ADDENDUM NUMBER TWO (2)

Project: New Justice Court Facility
Marshall County Justice Complex
Holly Springs, MS
PN: 20005

**JUSTICE COURT FACILITY ADDITION TO
MARSHALL COUNTY JUSTICE COMPLEX
HOLLY SPRINGS, MISSISSIPPI**

ADDENDUM NO.2

SHEET C.3 "GRADING AND DRAINAGE"

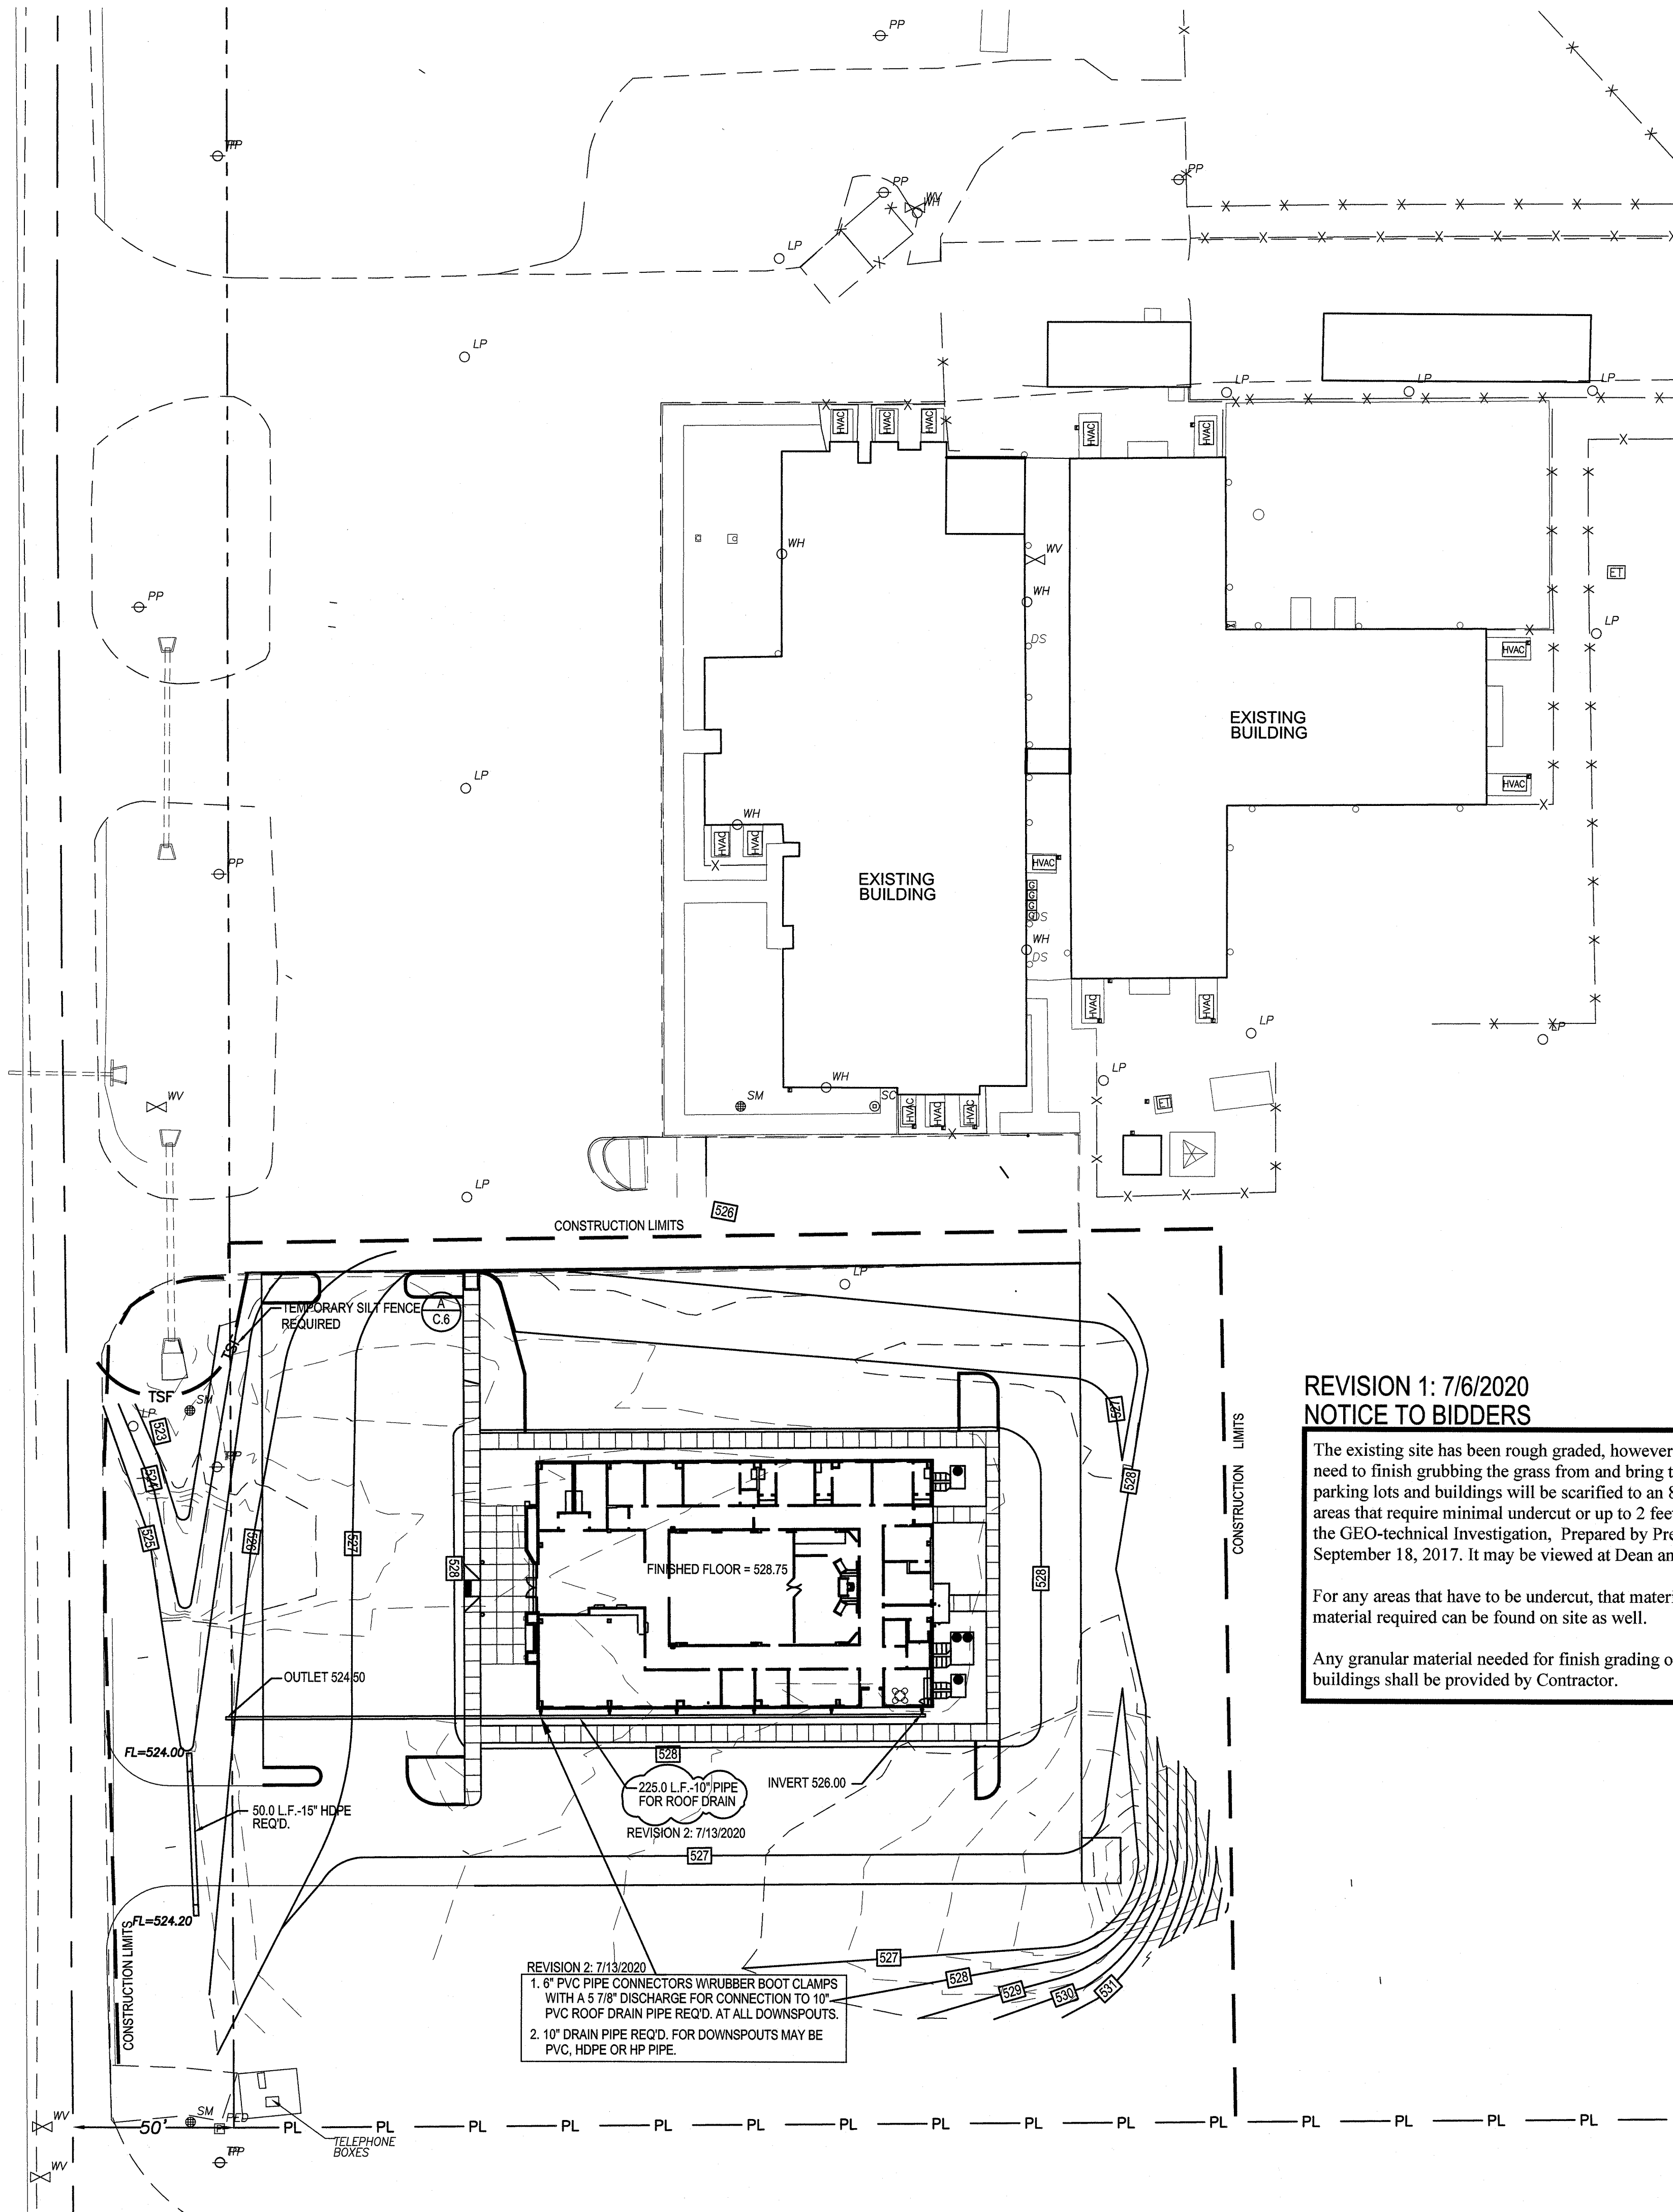
Note was added to clarify connection of 6" roof drain downspouts to 10" drain pipe. Drain pipe may be PVC, HDPE or HP. Remove Sheet C.3 and Replace with the attached revised Sheet C.3.

Sheet Number : **C.4**
 A NEW JUSTICE COURT FACILITY FOR MARSHALL COUNTY JUSTICE COMPLEX
 HOLLY SPRINGS, MISSISSIPPI

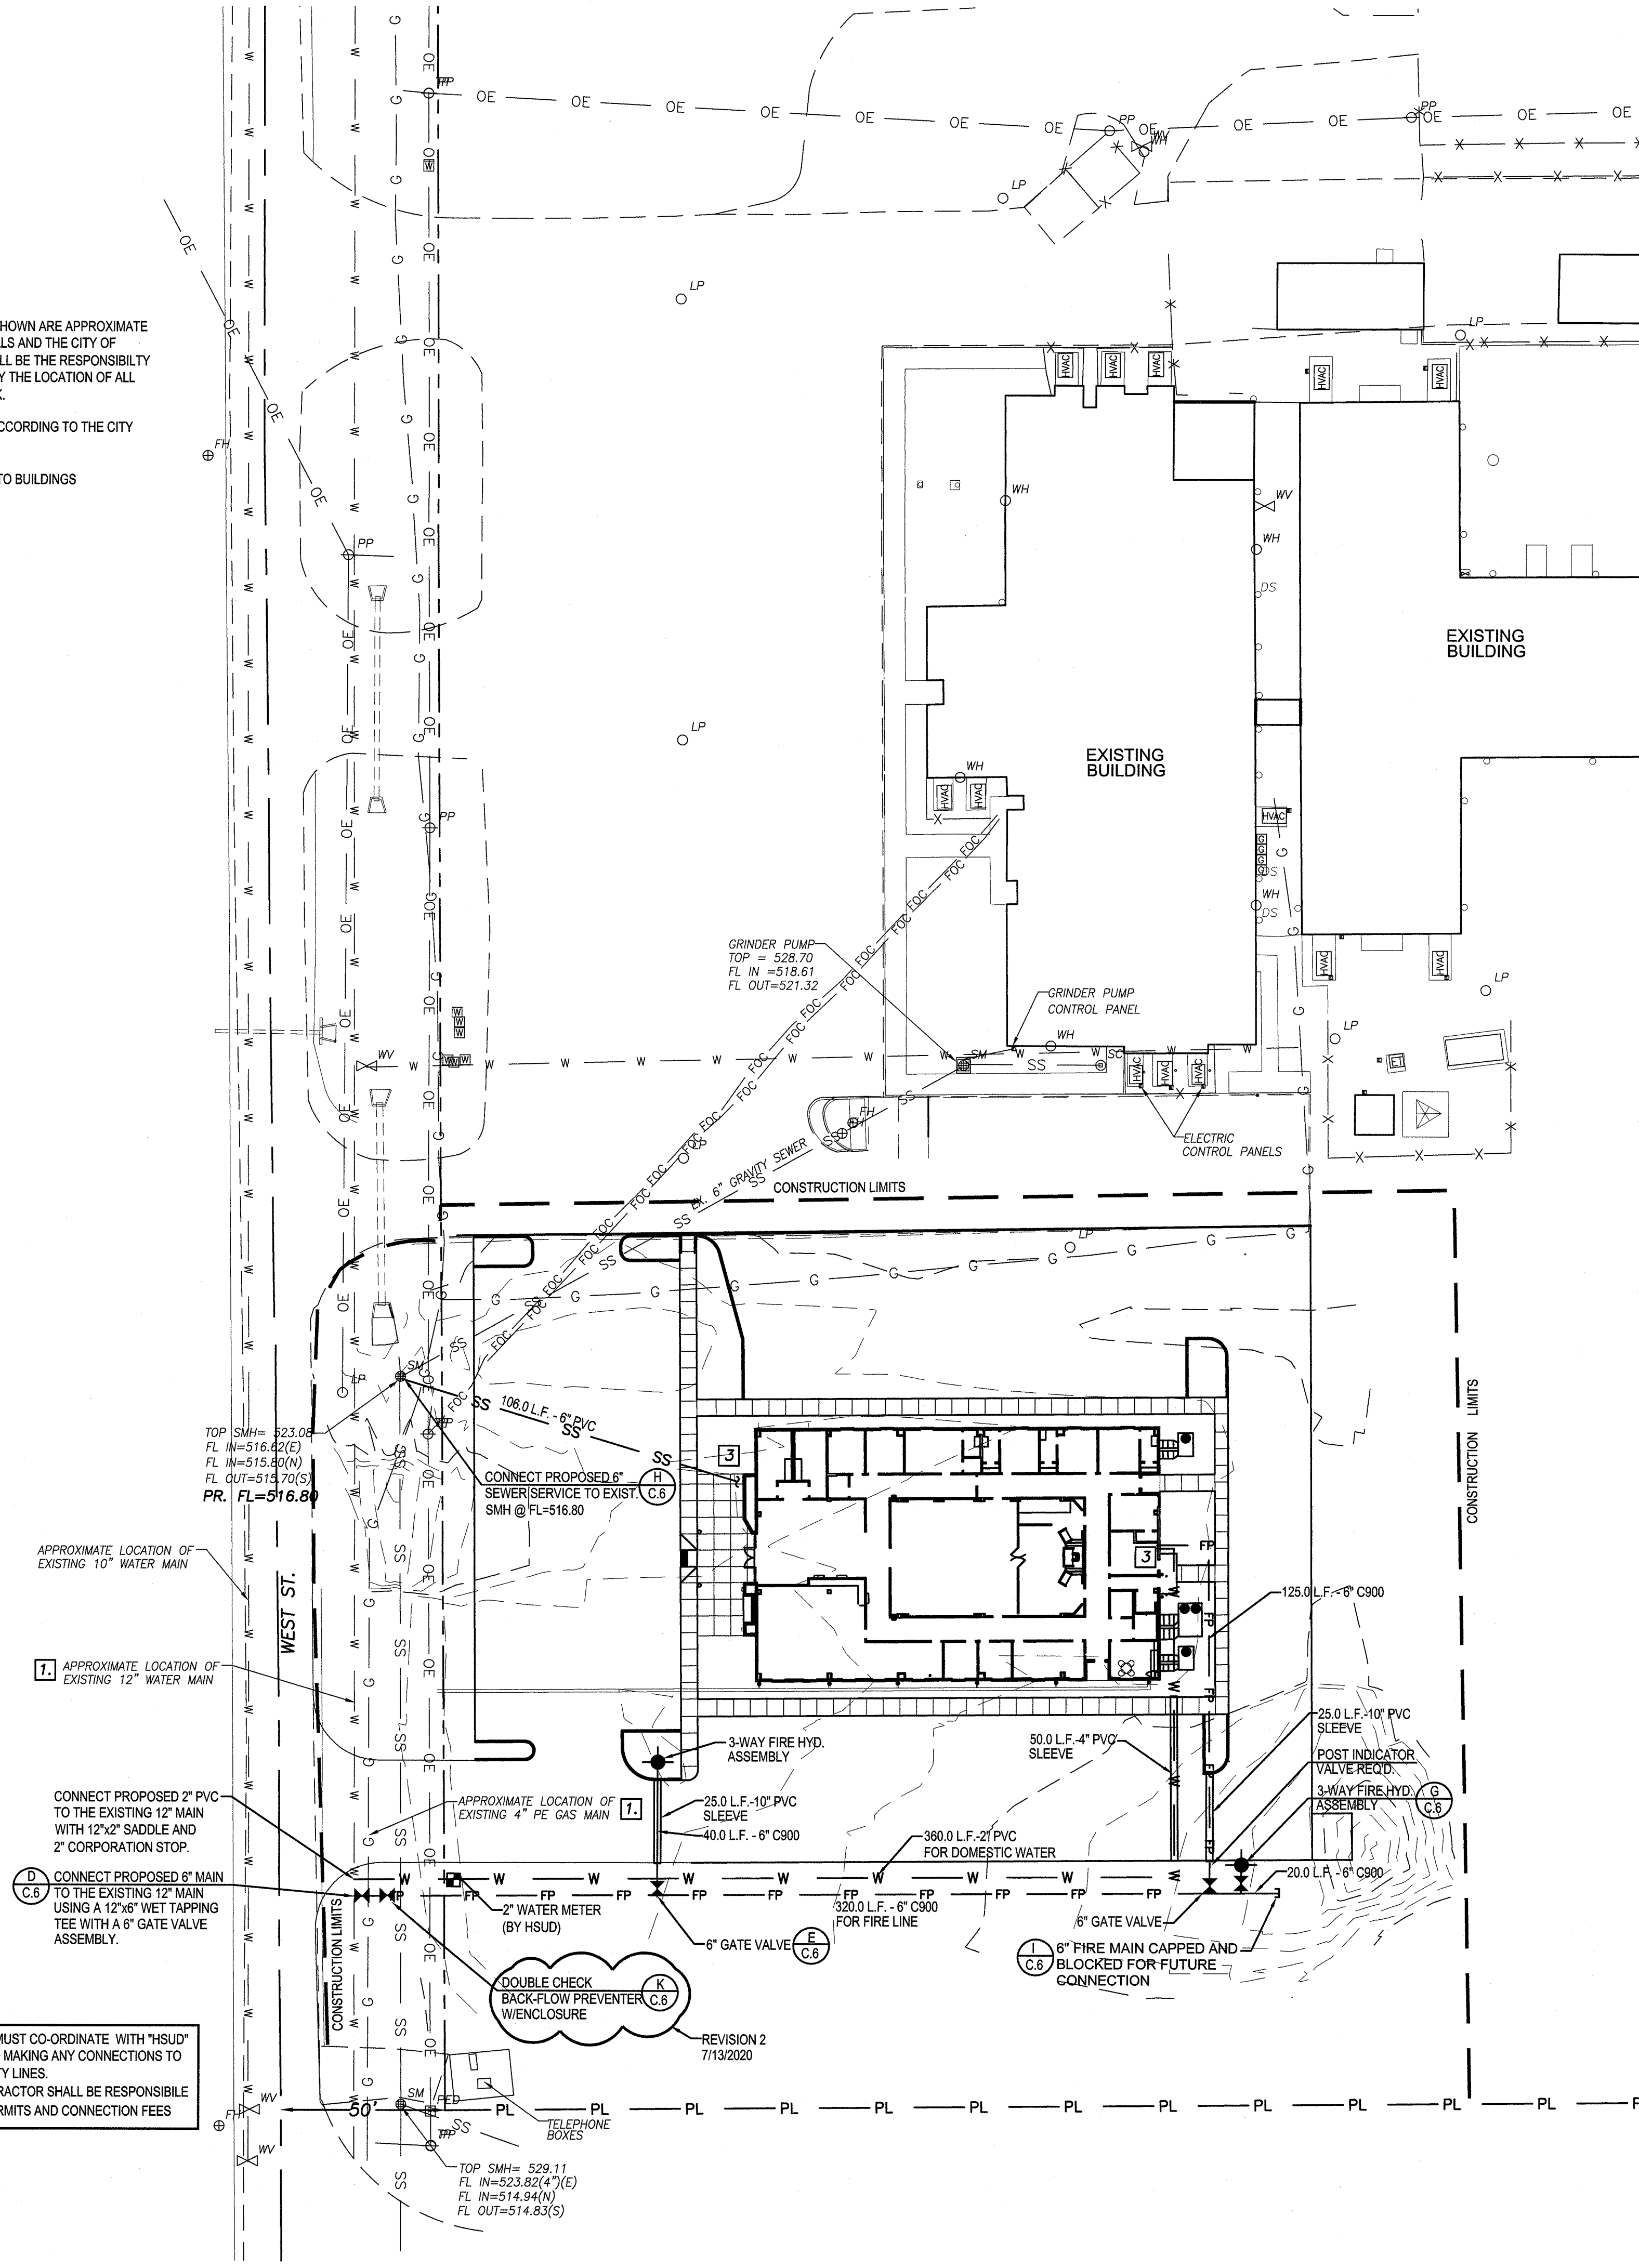
The Check Valve on the fire protection line was replaced by a Double Check Back-Flow Preventer, covered in Section 2.9.7 of Water Technical Specifications. Remove Sheet C.4 and Replace with the attached revised Sheet C.4.

BACK-FLOW PREVENTER
NO SCALE (K)

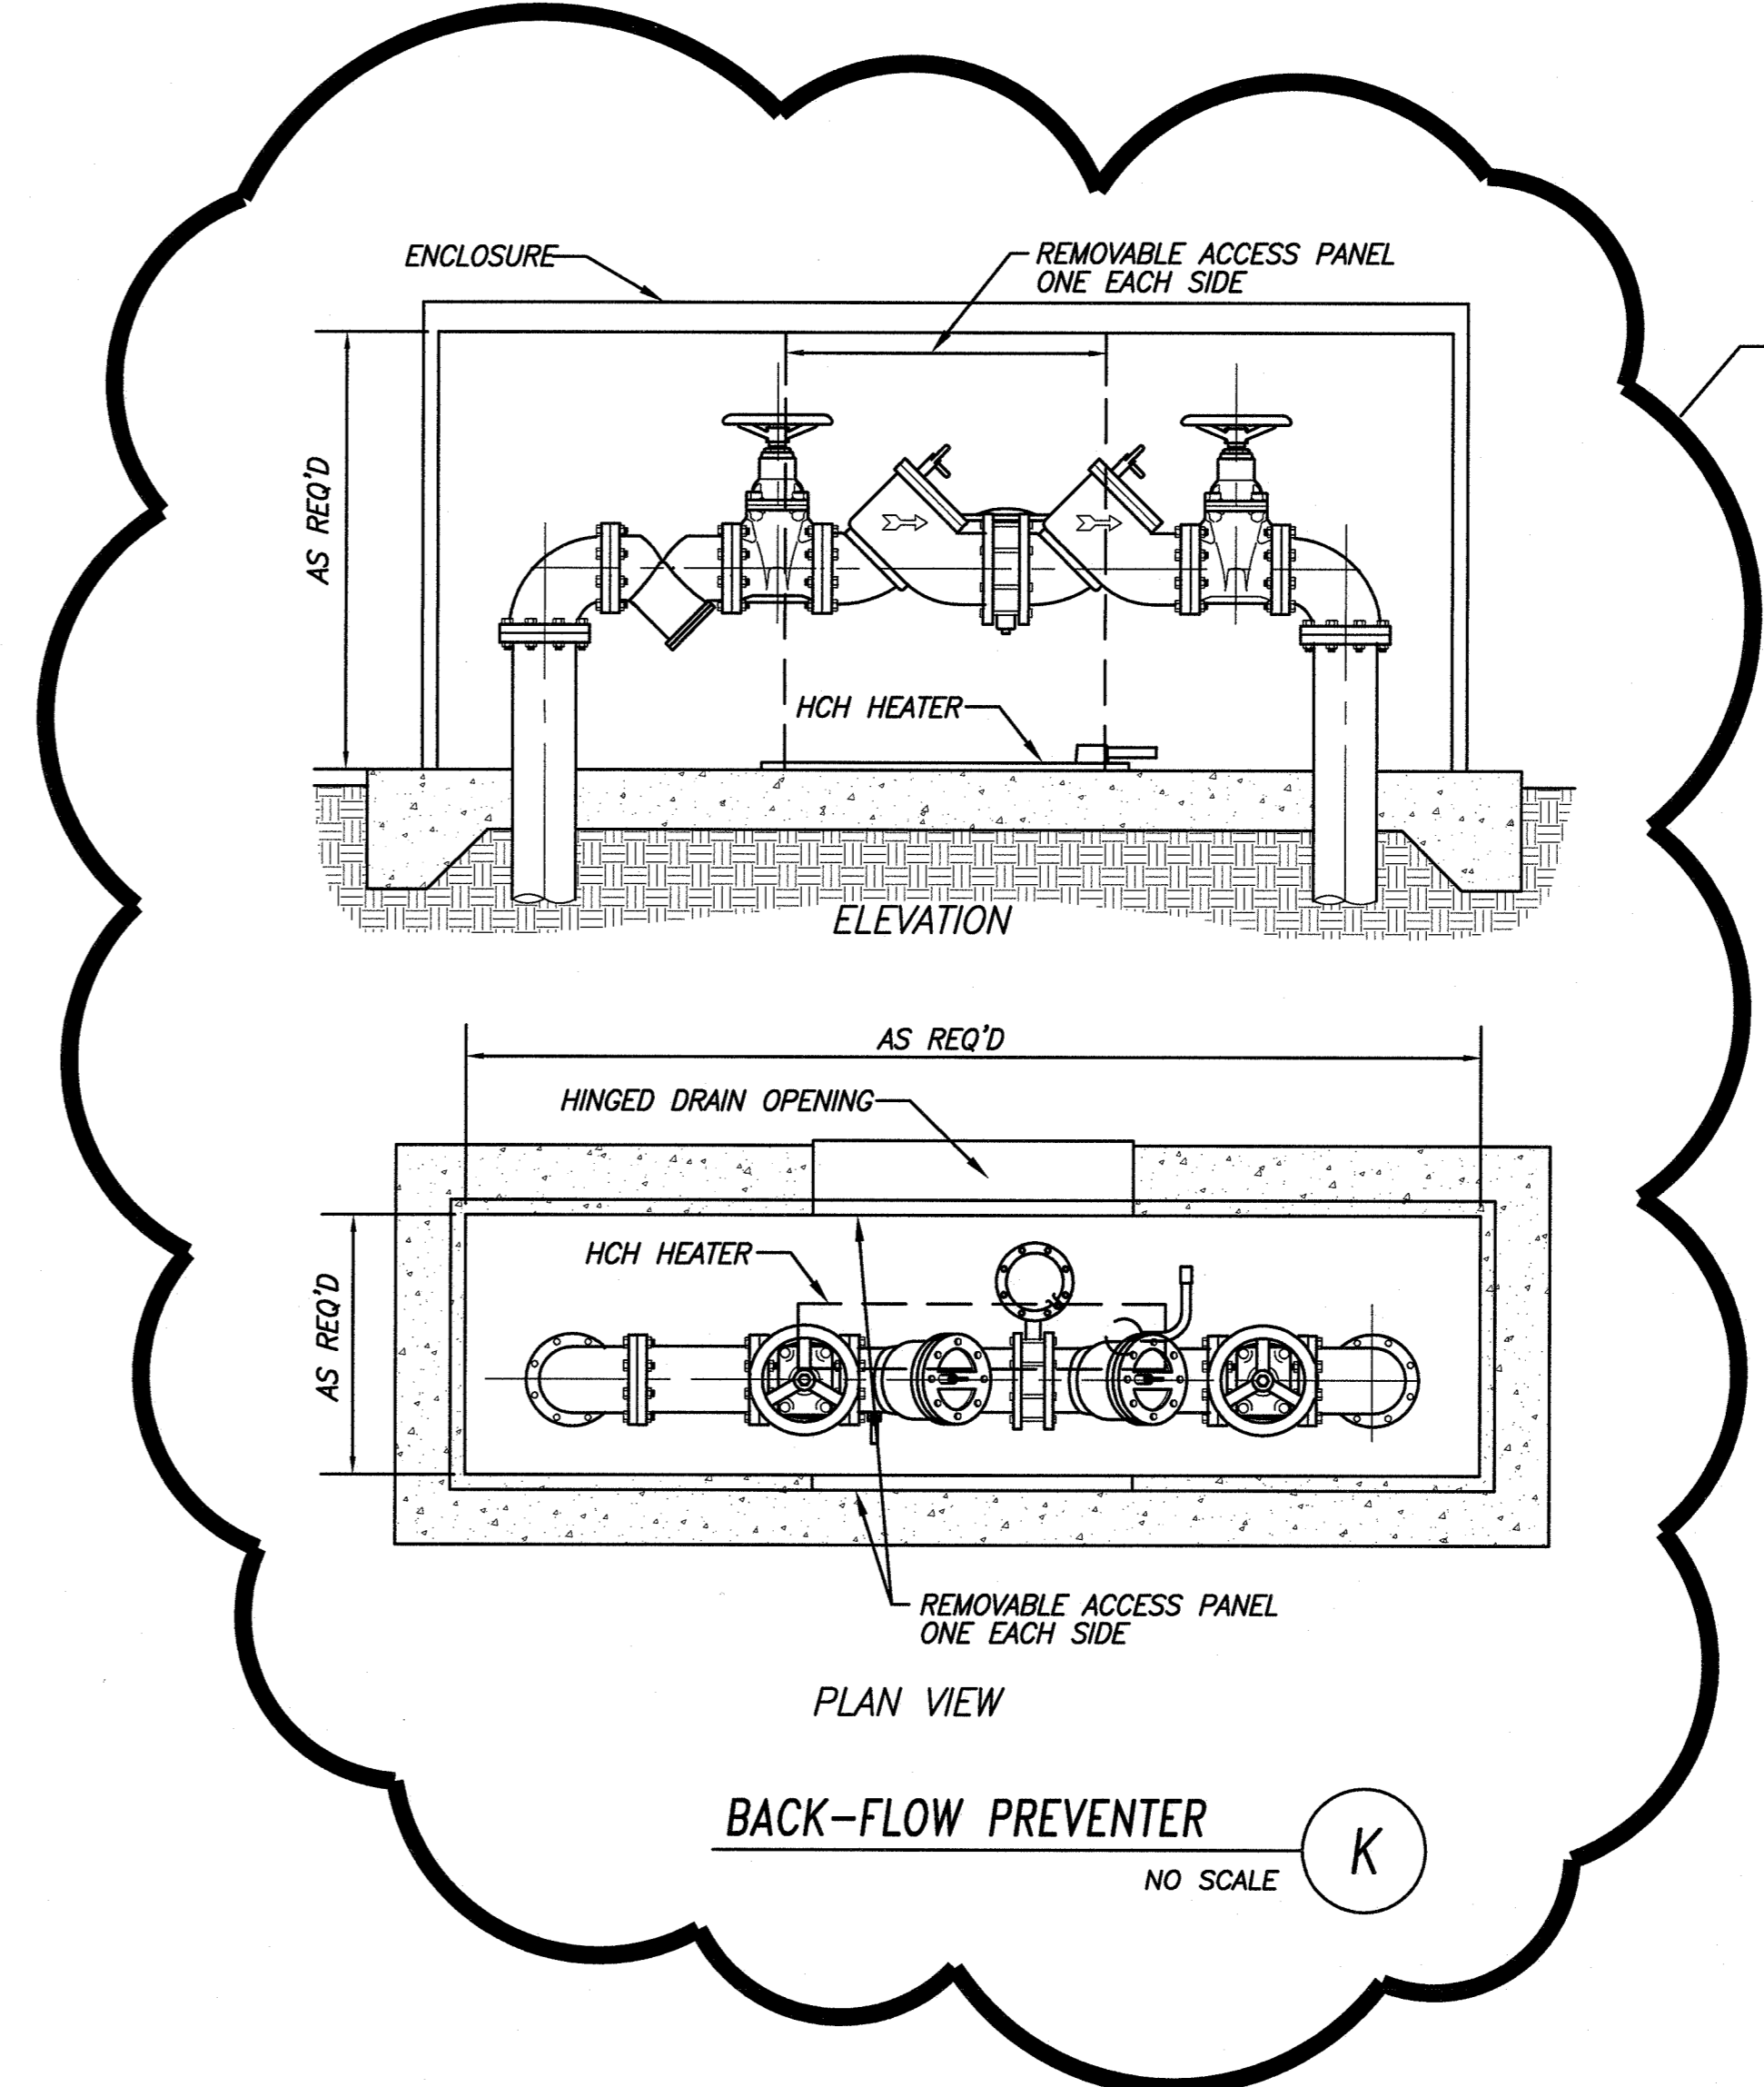
A detail for a Double Check Back-Flow Preventer was added to Sheet C.6 for clarification to contractor. Remove Sheet C.6 and Replace with the attached revised Sheet C.6.
